UNITED STATES
DEPARTMENT OF THE INTERIOR
BUREAU OF LAND MANAGEMENTFORM APPROVED
OMB NO. 1004-0137
Expires: January 31, 2018**SUNDRY NOTICES AND REPORTS ON WELLS**
*Do not use this form for proposals to drill or to re-enter an abandoned well. Use form 3160-3 (APD) for such proposals.*5. Lease Serial No.
NMNM94651

CEDAR CANYON 28 FEDERAL 9H

OXY USA Inc. respectfully requests approval for the following changes to the approved APD:

General well schematic:

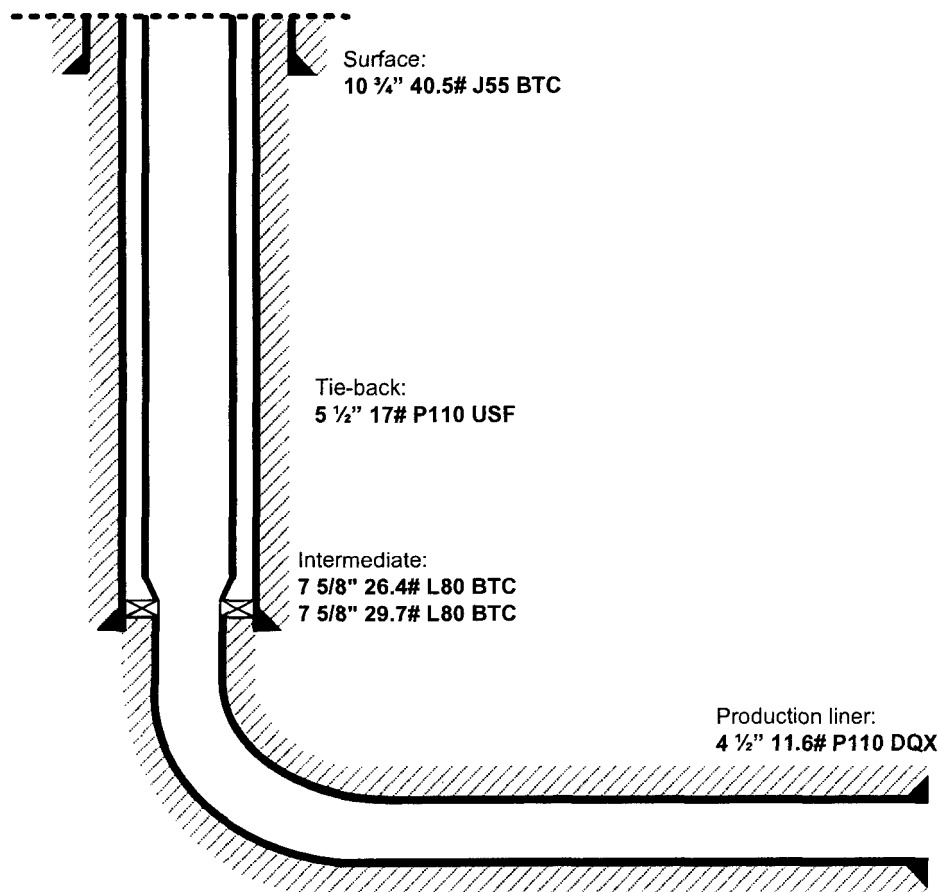
- **Change casing program**
 - a. Change surface casing depth consistent with other wells on pad.
 - b. Run a 4-1/2" production liner
 - c. Update production casing

- **Change cementing program**
 - a. Due to changing casing set points, the planned cement volume will be adjusted.
 - b. OXY is requesting permission to have minimum fill of cement behind the 4-1/2" production liner to be 100' into previous casing string. The reason for this is so that we can come back and develop shallower benches from the same 7-5/8" mainbore in the future.
 - c. Cement will be brought to the top of this liner hanger

- Drill 14-3/4" hole x 10-3/4" casing for surface section. Cement to surface.
- Drill 9-7/8" hole x 7-5/8" casing for intermediate section. Cement to surface.
- Drill 6-3/4" hole x 4-1/2" liner for production section. Cement to top of liner, 100' inside 7-5/8" shoe.
- Release drilling rig from location.
- Move in workover rig and run a 5-1/2" 17# P110 USF tie-back frack string and seal assembly (see connection specs below). Tie into liner hanger Polished Bore Receptacle (PBR) with seal assembly.
- Pump hydraulic fracture job.
- Flowback and produce well.

When a decision is made to develop a secondary bench from this wellbore, a workover rig will be moved to location. The workover rig will then retrieve the tie-back frack string and seal assembly before temporarily abandoning the initial lateral.
